TOWN COUNCIL COMMUNICATION

AGENDA ITEM: Conduct a Public Hearing to hear public comment, discuss, and consider a Site Plan Amendment for Guidance Preparatory Academy, located at 64 McMakin Road in the Town of Bartonville. The Amendment consists of changes to the landscaping plan for the commercial property. The applicant is Kathryn Taylor. [Town of Bartonville File Number SP-2025-001]. ***(The Planning & Zoning Commission recommended approval, with conditions, by a vote of 4-1 at its August 6, 2025, meeting.)***

**TOWN OF BARTONVILLE
SITE PLAN APPLICATION/SITE PLAN
AMENDMENT APPLICATION**

Exhibit A: Site photos dated December 5, 2023

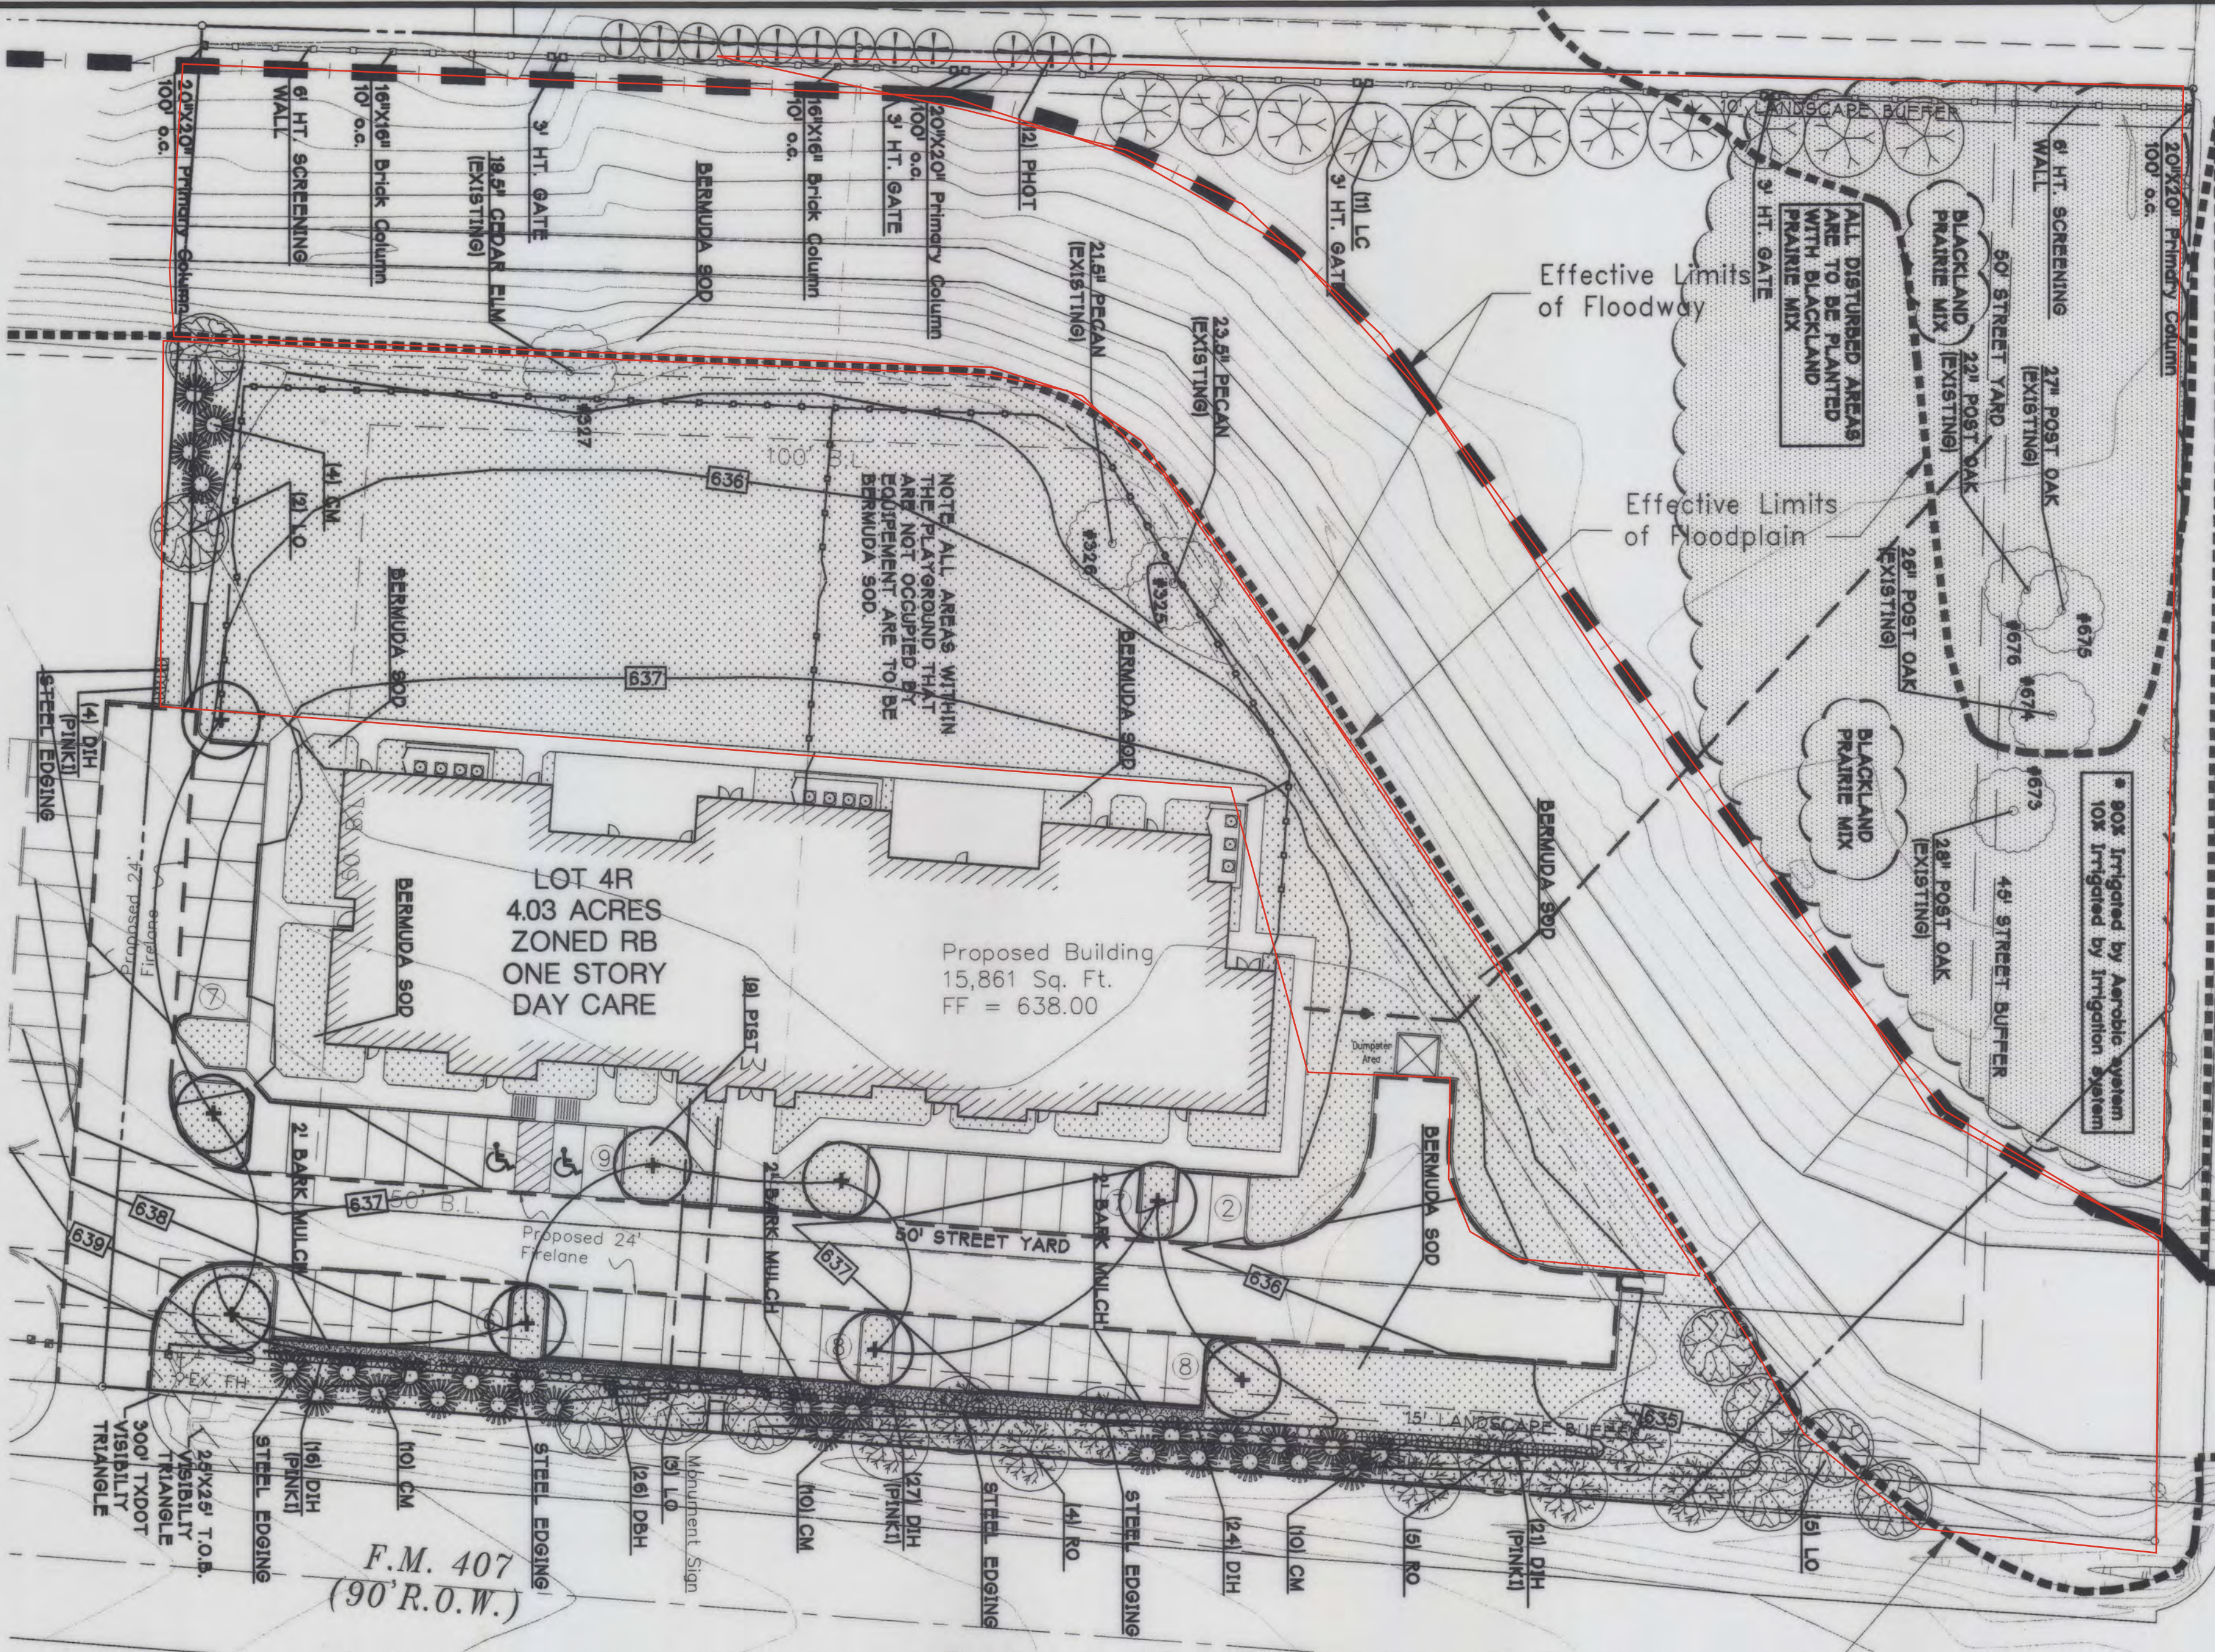
The Town of Bartonville has been made aware of the removal of landscaping from your commercial site, in violation of the Town's Landscape Requirements, specifically the Maintenance provisions found in Section 18.8 of the Bartonville Zoning Ordinance. Based on reconnaissance of the site (see attached photos), it appears that up to 11 Leland cypress trees and 12 photinia trees were removed as part of a site clearing effort related to utility easement maintenance and septic system expansion. These plants were part of the approved landscape plan for the site, approved by the Town of Bartonville on 2008 (see attached landscape plan).

1. You may replant the trees as shown in the approved landscape plan, ensuring their survival to maturity and ongoing maintenance; or
2. You may submit a site/landscape plan amendment request to the Town, providing an explanation as to why you cannot maintain the trees as they were initially planted and approved. This request would have to provide an alternative planting plan to maintain compliance with Chapter 18 of the Bartonville Zoning Ordinance.
